ADDENDUM #1

Reference: Restroom Remodel – Dead Horse Point State Park
Division of Parks and Recreation, Moab, Utah
DFCM Project No.07321510

ADDENDUM NO. 1

Dead Horse Point
Restroom Improvements
Division of Parks and Recreation
State Road 313, P.O. Box 609
Moab, Utah
DFCM Project No. 07321510

ADD ALTERNATE #2 PLAN CLAIRIFICATION

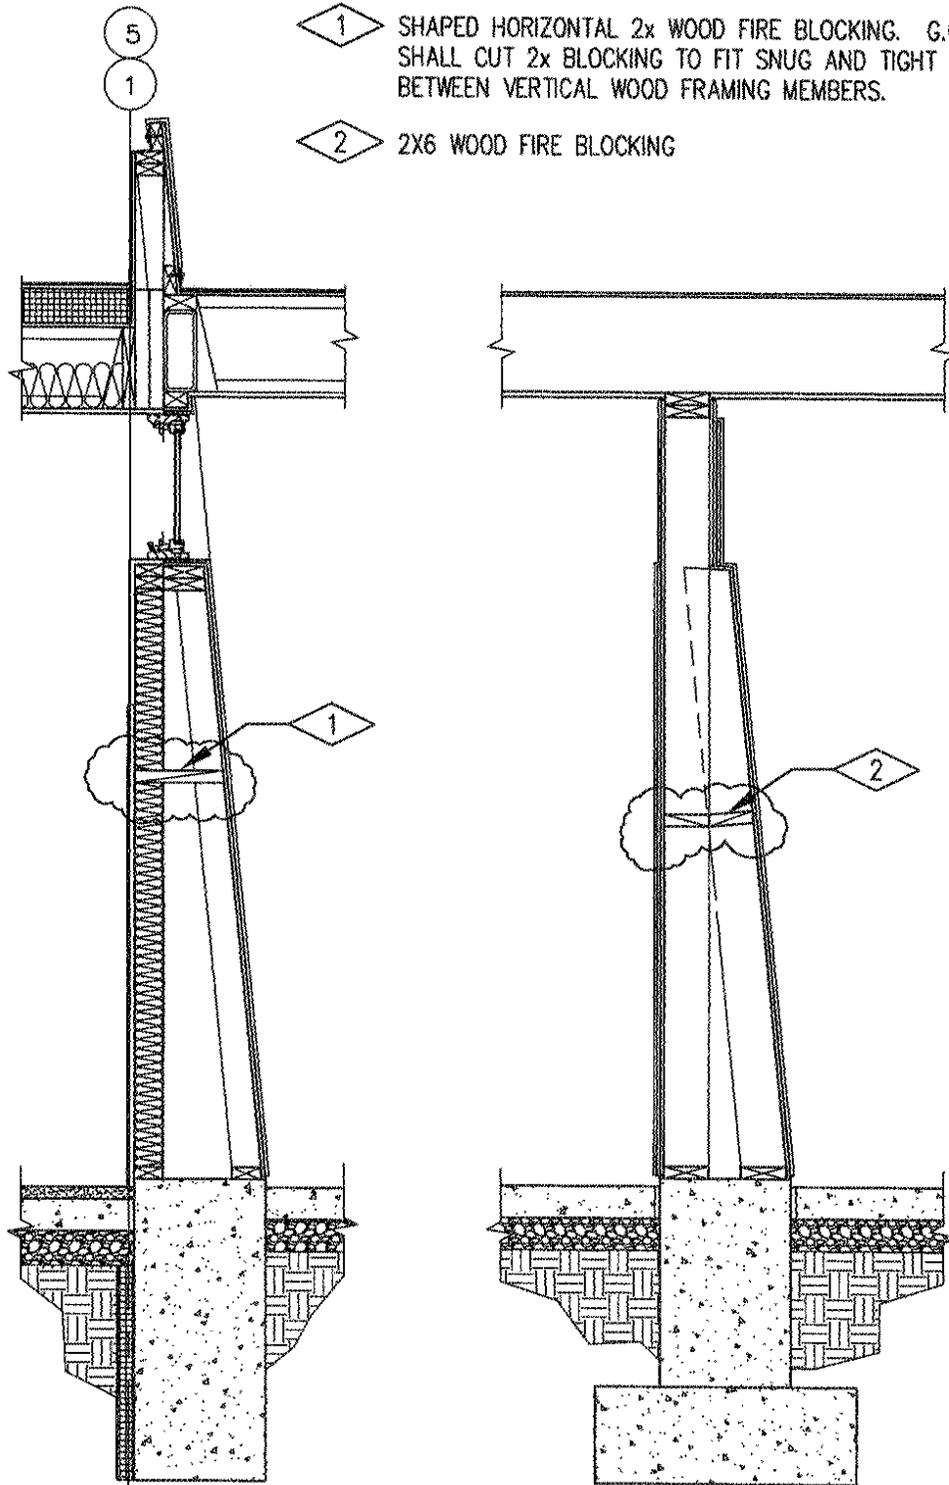
3. See attached addenda drawing 01/AD01. 8-1/2"x11" addenda drawing provides further clarification for add alternate #2 and the location of the wall that will have stone veneer applied to them.

- 1 LOCATION OF WALL SURFACES ON EACH RESTROOM TO HAVE STONE VENEER APPLIED AS PER ADD ALTERNATE #2. ALSO, DUMPSTER ENCLOSURE TO HAVE STONE VENEER AS PER ADD ALT #2

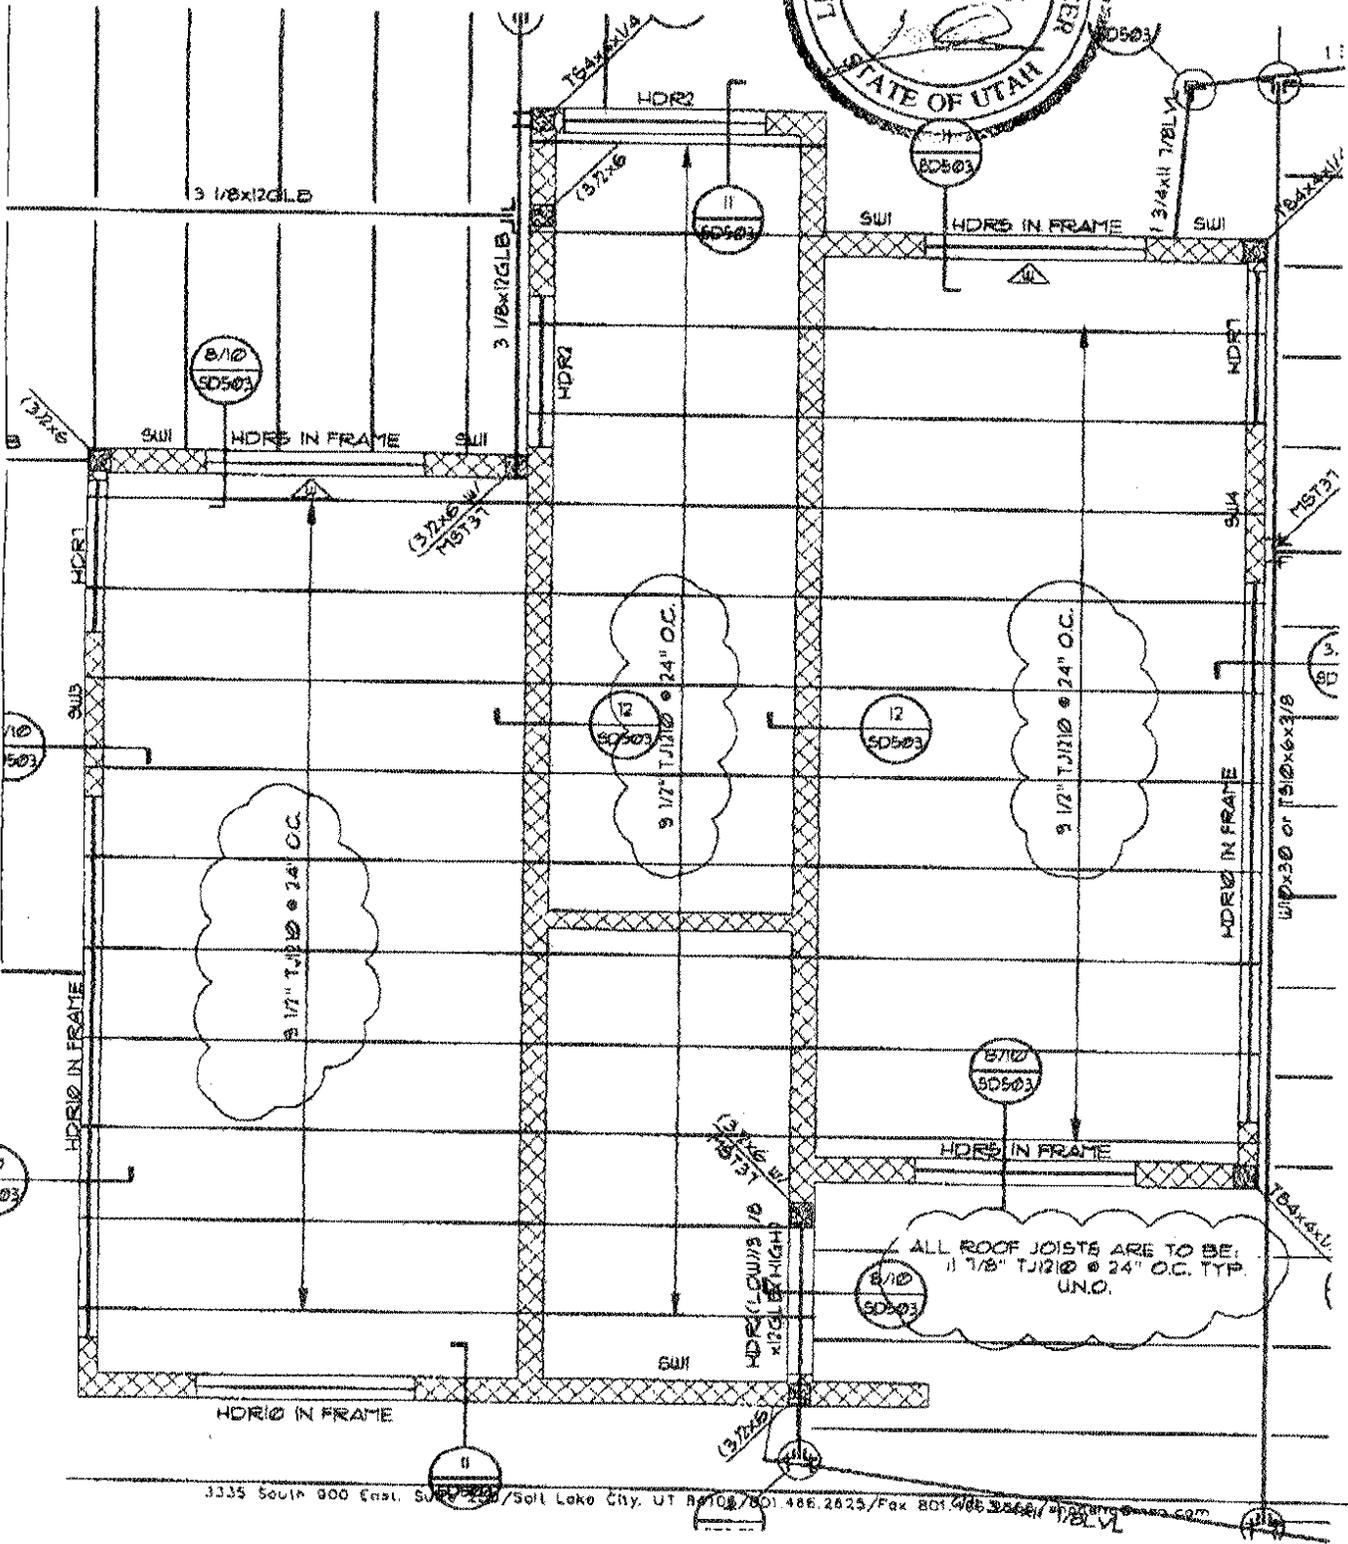
1. See attached 8-1/2"x11" structural addenda drawing indicating roof joist framing sizes in bubbled areas.
